Comments on the Gazebo project proposed by 8636 House owner Cui

Here is a link to the permit documents for building permit 2401-034:

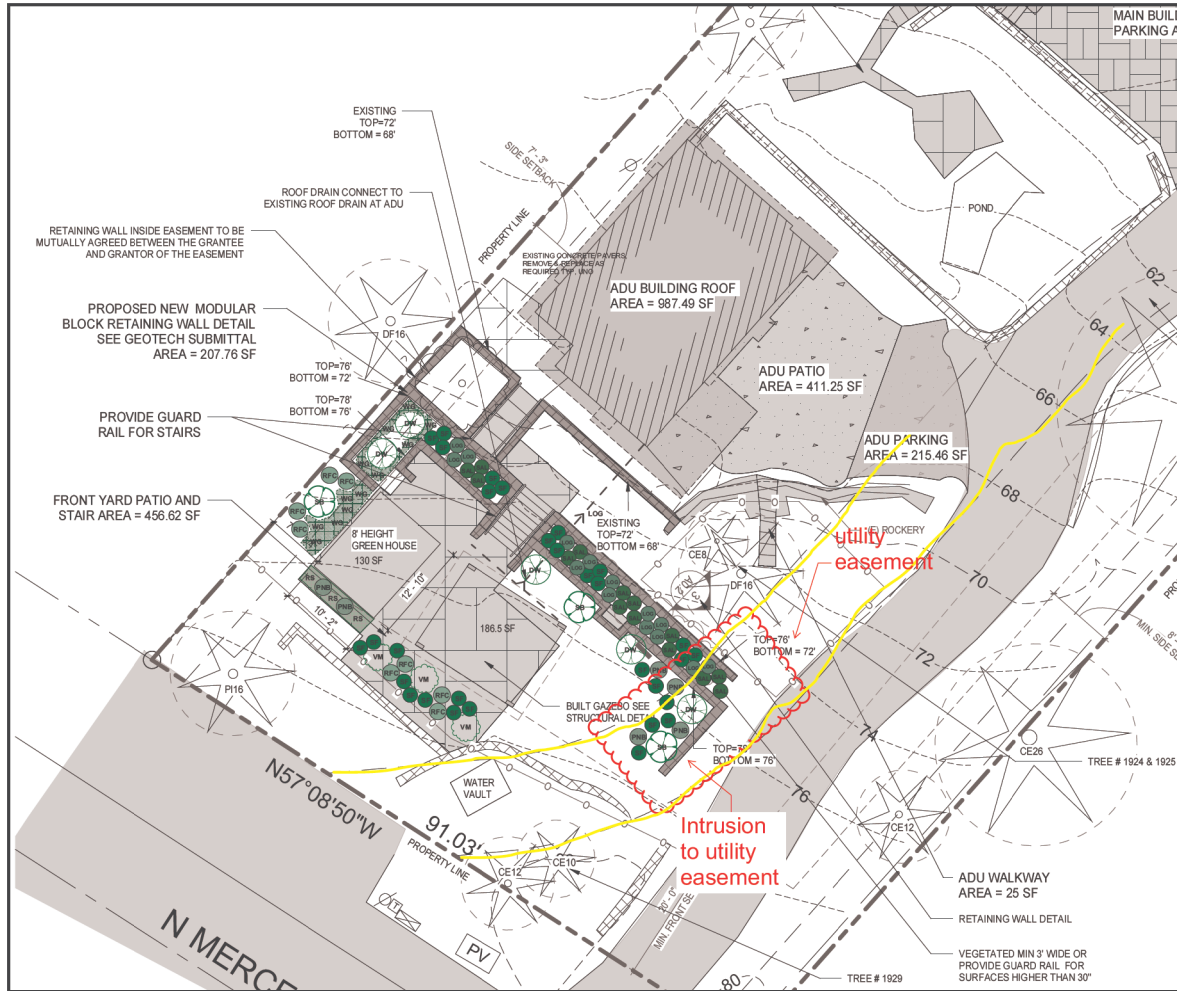
1. The retaining wall is still located within the utility easement, and I also noticed that several shrubs are positioned inside this area. As far as I understand, no structure—including a retaining wall—should be placed within a utility easement, as it would obstruct access for maintenance or emergency purposes.
2. The plan does not show the existing gazebo location (that is non-compliance), nor include a demolition plan for removing the existing structure (non-compliance). Without this information, it may give out a wrong message to the contractor. The plan should include this information so it is very clear for the purpose of this permit - the job requires a re-building of the structure.
